EXHIBIT "C"
DESKTOP ANALYSIS

Subject: 851 Bethel Church Road (Nolt Trucking)
Wetlands and Watercourses Desktop Evaluation
CEC# 226808

RE: Regulated Features Desktop Site Evaluation Summary Letter of Findings
851 Bethel Church Road Property
East Coventry Township, Chester County, PA
PTE# 6144

PTE 6144 851 Bethel Church Road

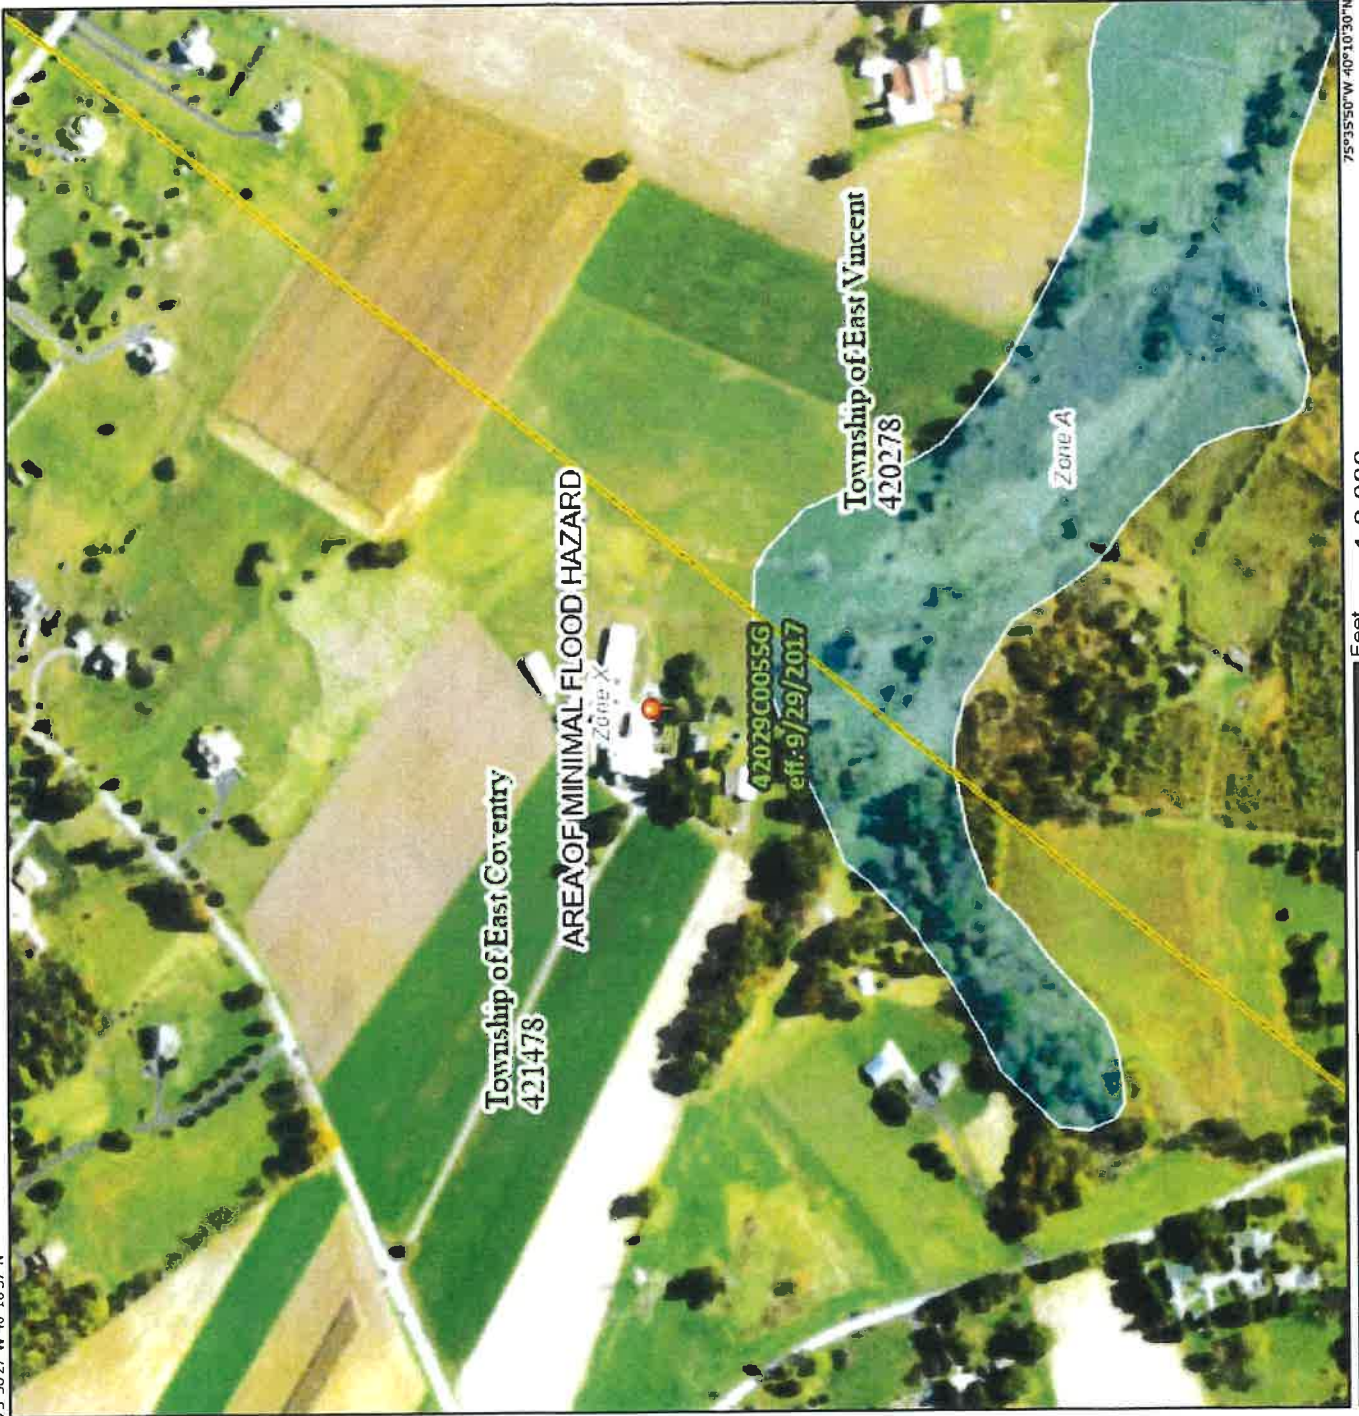
Google Earth view of general area of tank installation. view of Features PTE would consider potentially Regulated waters with wetland system associated
